# Report to Strategic Sites Committee

Sevenhills Road and Part Of Southlands and Pinewood Roads, To The North & East Of Pinewood Studios, Iver Heath, Buckinghamshire

Realignment, resurfacing and improvement works, with associated landscaping and engineering works to Sevenhills Road, Iver Heath. Additional vehicular access to Pinewood Studios site.

**Application Number:** PL/19/4430/FA  
**Applicant:** Pinewood Group Limited  
**Case Officer:** Laura Peplow  
**Ward affected:** Iver Heath  
**Parish Town Council:** Iver Parish Council  
**Valid date:** 23 December 2019  
**Determination date:** 17 April 2020

### Seven Hills Road/Denham Lane (A412)

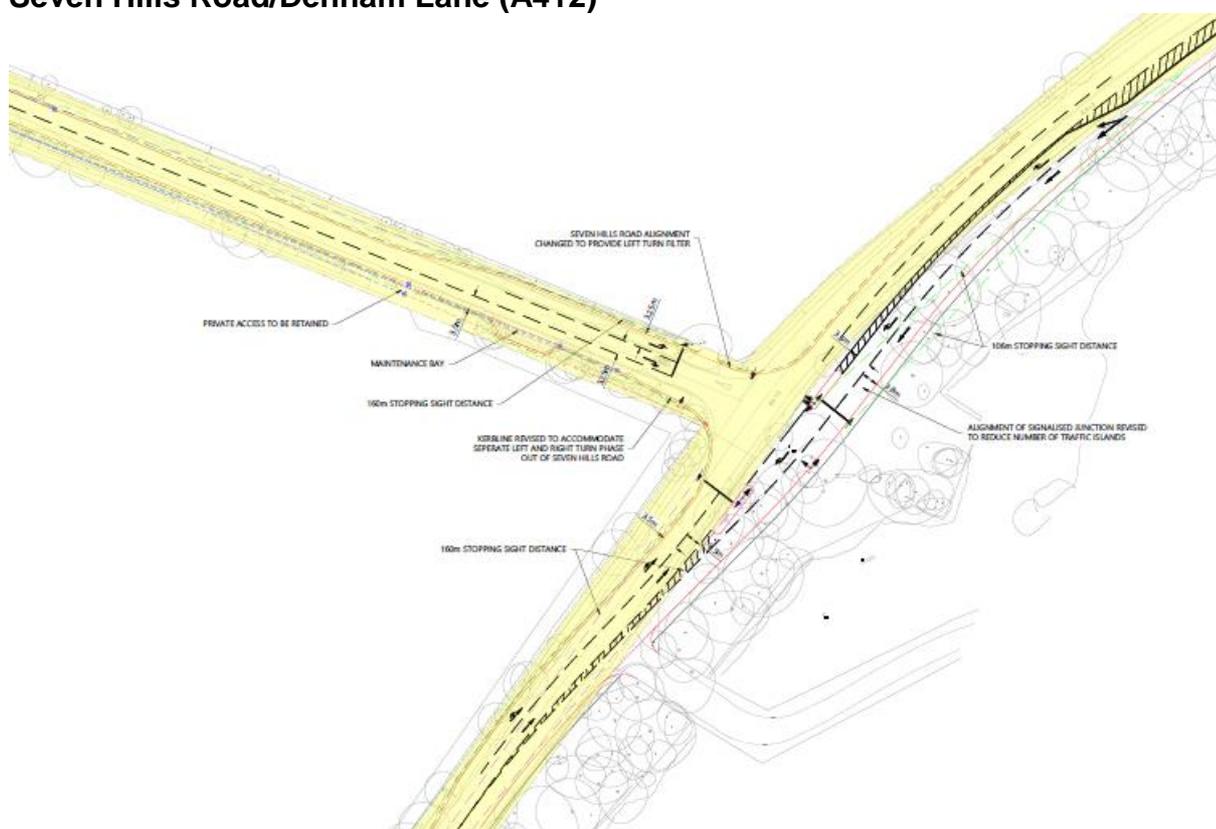
At the eastern end of Sevenhills Road, a signalised T junction is proposed. The Highway Authority has through the application process identified that any proposals at this junction will only be acceptable if they do not have an undue impact on the A412 Denham Road/Southlands Road. The scheme proposed seeks to ensure that the capacity is maintained on the A412 by means of local widening of the highway to provide additional carriageway and capacity at the stop lines in the form of two approach lanes. It is also proposed that Sevenhills Road will be widened to two lanes at the stop line.

The A412 southbound is proposed to have a single lane ahead movement with a dedicated right turn lane, whilst the northbound is proposed to have a left and ahead lane and a dedicated ahead lane. The widened Sevenhills Road is proposed to have single left and right turning lanes at the stop line. The principle of this layout is acceptable to the Highway Authority, however concerns have been raised regarding the size of the areas that do not have complete inter visibility between the stop lines. Having given this consideration, it is the view of the Highway Authority that through the detailed design process it would be possible to

## Sevenhills Road

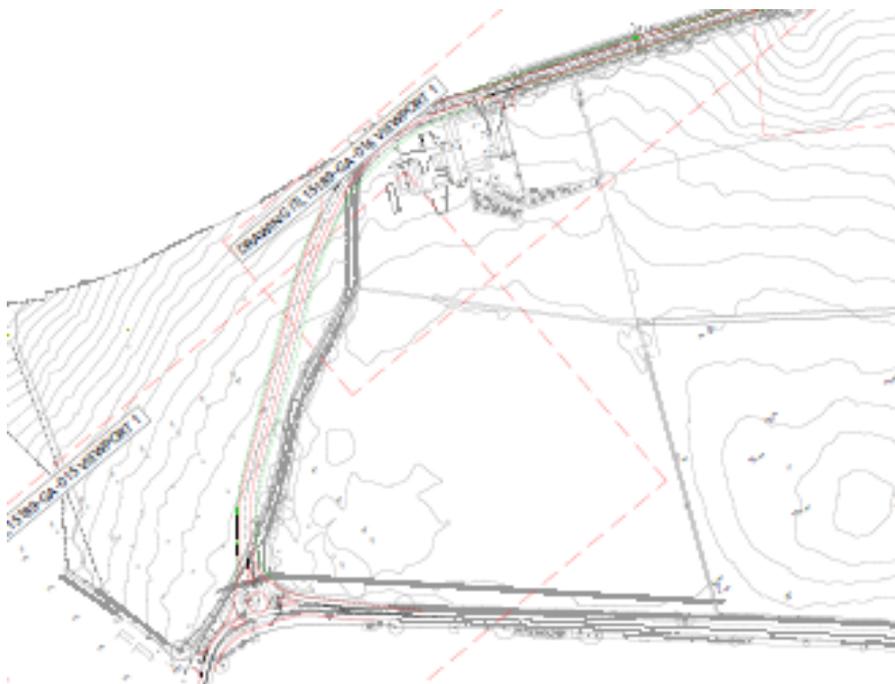
It is proposed to upgrade the carriageway of Sevenhills Road along its length, with the notable exception of any changes to the bridge spanning the M25, which is already of a sufficient width to safely accommodate two way vehicular traffic. A replacement section of road between the rear access to the Pinewood East site and Pinewood Road is proposed, with the existing road between these points being removed and 'stopped up'.

The carriageway is proposed to be 6m in width along the length, with wider sections on bends, allowing for the free passage of HGV's along the road in both directions. The Road is intended to be an attractive alternative to routes through Pinewood Green, FPR and Iver Heath between the Studios and the M40.

**Plan 2 - Bridleway IVE/32/2 at the Denham Road - Sevenhills Road junction**

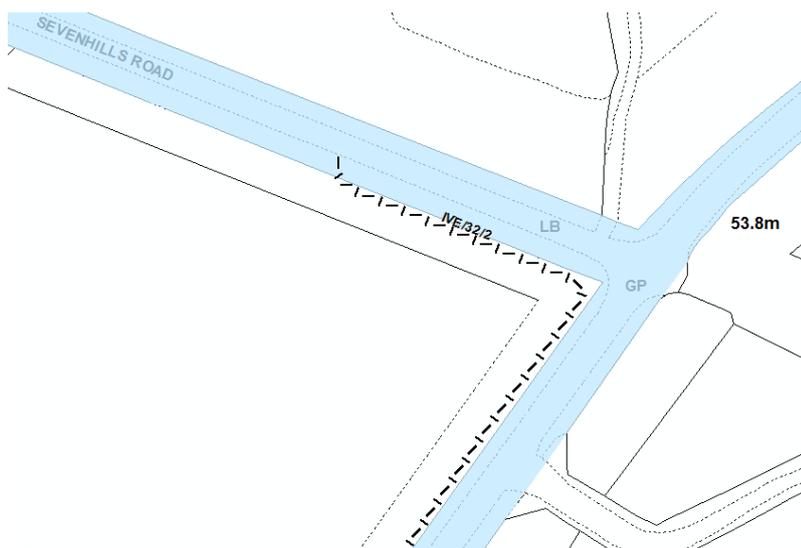
Turning to the application itself, the proposals do not impact directly on the footprint of the aforementioned rights of way. The carriageway widening around Sevenhills Road junction with Denham Road does not impact on Bridleway IVE/32/2, which remains behind the existing hedge. This bridleway then exits onto Sevenhills Road at a point 60m from Denham Road where the additional junction-related lane widening starts and ends. Bridleway IVE/32/2 is shown in more detail in Plan 2 for information.

**Plan 3**

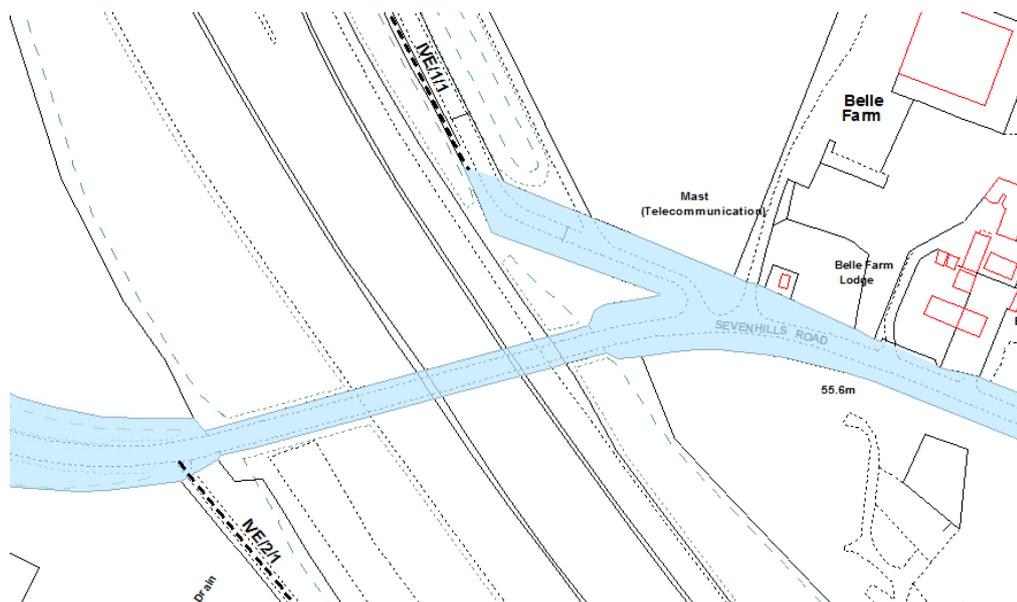
On the eastern side of the M25, pedestrians connect along the existing vehicular highway off Sevenhills Road leading to Cherry Orchard Farm to link with Footpath IVE/1/1 – see Plan 3. This is marked on Drawing ITL15189-GA-0 as 'PRIVATE ACCESS TO BE RETAINED' and the proposal appears satisfactory for walkers.

On the western side of the M25 pedestrians exit Footpath IVE/2/1 from The Clump woodland (see Plan 3 above) and join the Sevenhills Road to make onward connections west along the verge and east along the existing footway over the M25 bridge.

**Extract 1**

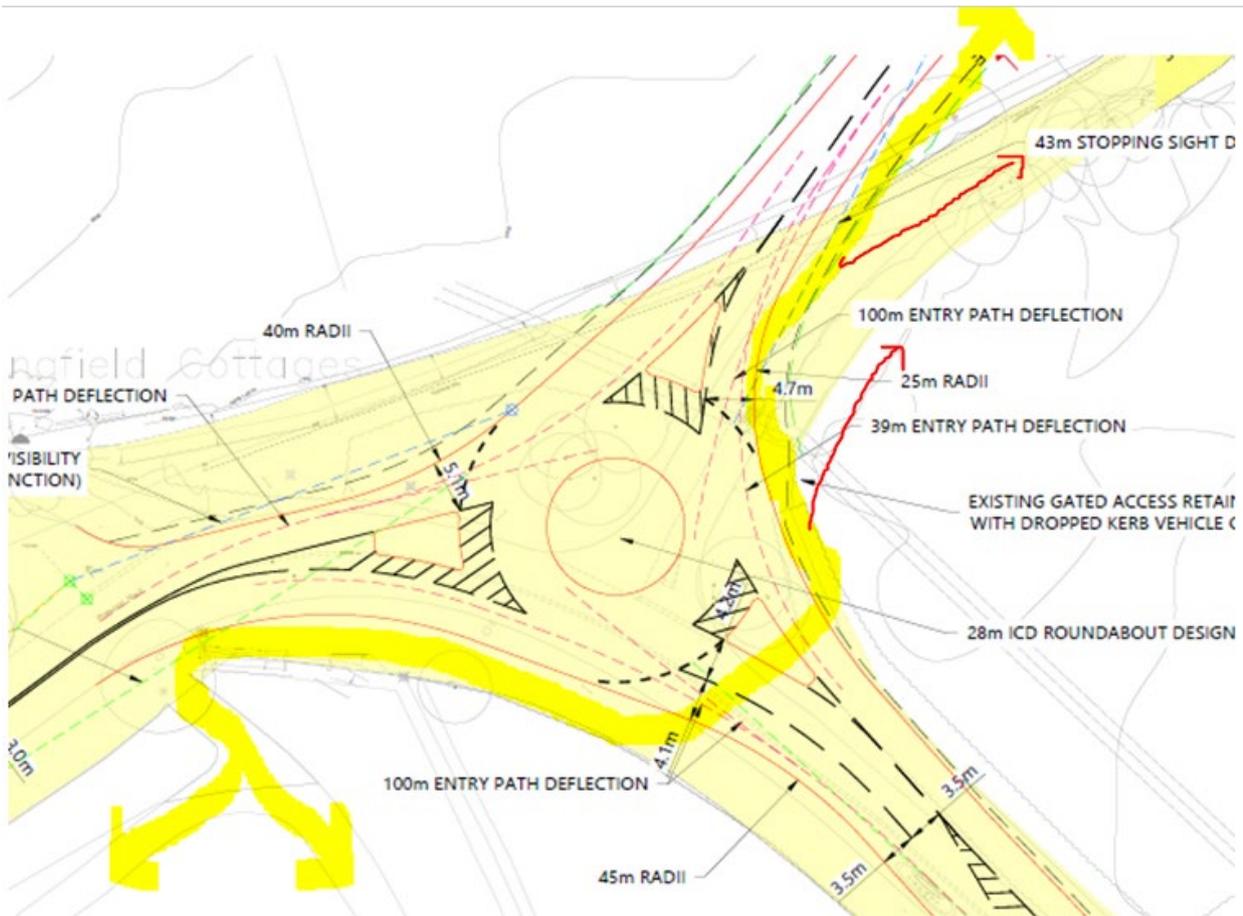
At the new Pinewood Road roundabout, walkers and cyclists, having emerged from Black Park's bridleways (WEX/21/1 and WEX/23/1) and wishing to connect with the permissive path alongside Sevenhills Road, when these are available, will need verge space to make onward connections. I have requested provision for users to navigate the southern side of the roundabout, as shown yellow on Extract 1. This also allows horse riders to continue their journey along the new Sevenhills Road verge (southern side) if they wish to do so. The proposal simply involves setting aside a flat, grass verge space, ideally at least 3m wide. Pinewood's Transport consultant has posted the council a Technical Note with a plan illustrating the above route can be provided and I trust this can be secured within detailed design. Please refer to Highways Development Management's response for further information.

*Note: within Extract 1 two further options are sketched red: (i) along the old road; and (ii) along the existing permissive path. See later discussion.*

**Extract 2**

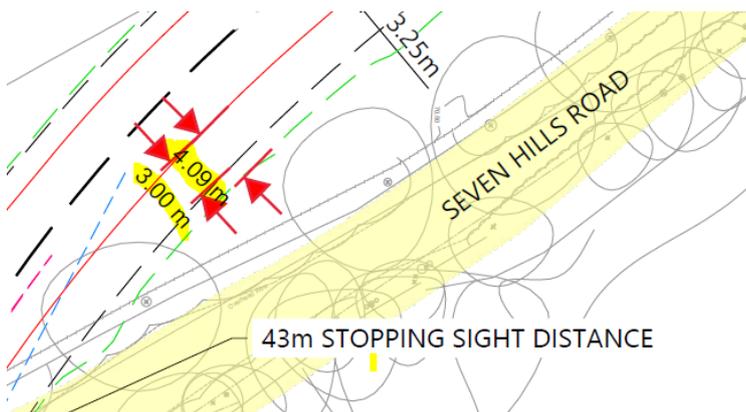
With regard the new section of Sevenhills Road between Pinewood Road and Saul's Farm, it would appear that good verge space has been allowed (see Extract 2) where a 3m verge is illustrated on the southern side of Sevenhills Road. While being alongside and close to on-coming traffic is not ideal, it does provide an option for walkers and horse riders making on-wards connections between the rights of way network. I trust a flat, usable, grass surface can be secured by condition or through detailed design - please refer to Highways Development Management's response for further information.
